Product Change Notification

MultiConnect[®] rCell 100 Series Cellular Routers

Date: November 1, 2021

PCN 10272021-003 (mPower - MTR)

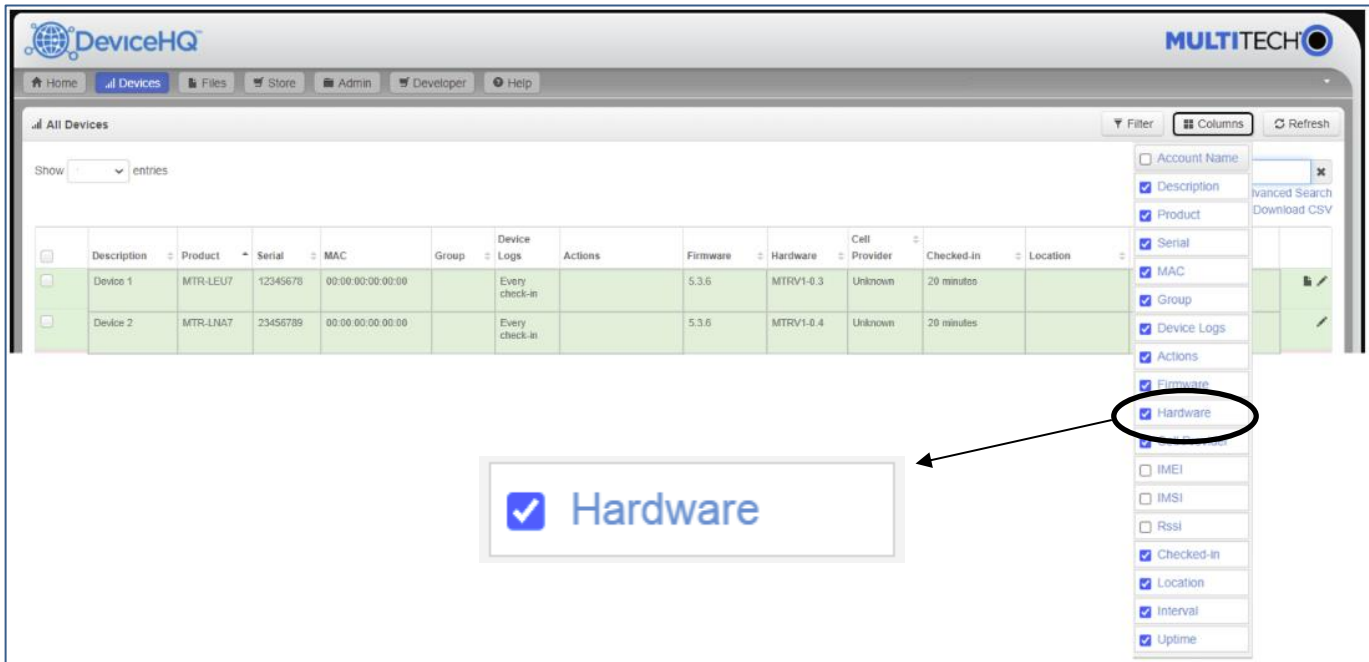
Some customers may need to understand if they are using an MTR LTE Category 4 device with original components or substitute components.

- MTR device with original components -- “MTRV1-0.3”
- MTR with substitute components -- “MTRV1-0.4”

1. **Model Numbers:** New model numbers are not required. Existing model numbers will continue to be used regardless of components.

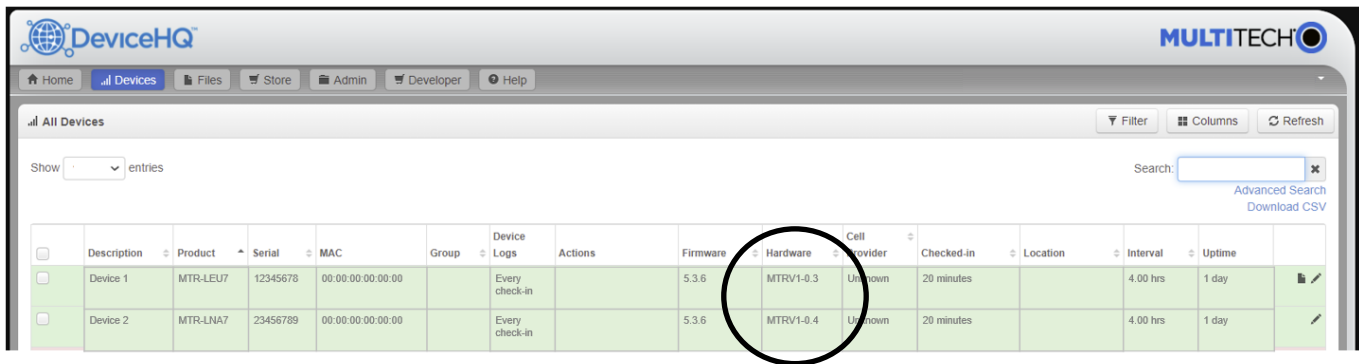
MultiTech DeviceHQ[®] is a cloud-based tool set for managing the latest generation of MultiTech devices, including the MTR devices. On the **DeviceHQ Device Page**, ensure that the Hardware field is chosen as a column selection in order to identify the hardware version.

Once this selection is made, the DeviceHQ dashboard will show the hardware version of each device:

- **MTRV1-0.3** - MTR device with original components
- **MTRV1-0.4** - MTR with substitute components

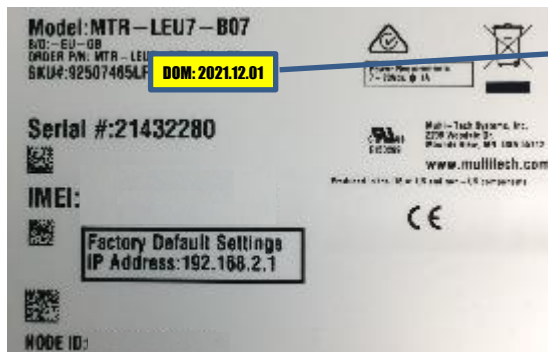
1. Downgrade Protection:
 - a. mPower 5.3.6 includes a means of identifying the MTR LTE Category 4 device (original components or substitute components) and limit the version of mPower that customers can use
 - i. Original Components: Downgrade to legacy mPower MTR versions is allowed
 - ii. Substitute Components: Downgrade is not available.
 - Devices with substitute components can only be used with mPower MTR 5.3.6 and later
 - Future mPower versions will not downgrade to versions of mPower prior to mPower MTR 5.3.6
 - b. The downgrade protection feature prevents customers from downgrading the MTR device to an unsupported version of mPower software.
 - c. DeviceHQ will include a similar feature that prevents customers from downgrading the MTR device to an unsupported version of mPower software.
 - d. Error Messages:

If a user attempts to downgrade the MTR with substitute components to an incompatible firmware version, an error message will be displayed:

- Downgrade using API Command: "Firmware check failed. Invalid firmware version for [MTRV1-0.4] hardware."
 - Downgrade using DeviceHQ: "Software check failed. Invalid firmware version for [MTRV1-0.4] hardware."
 - e. [GP-1386]
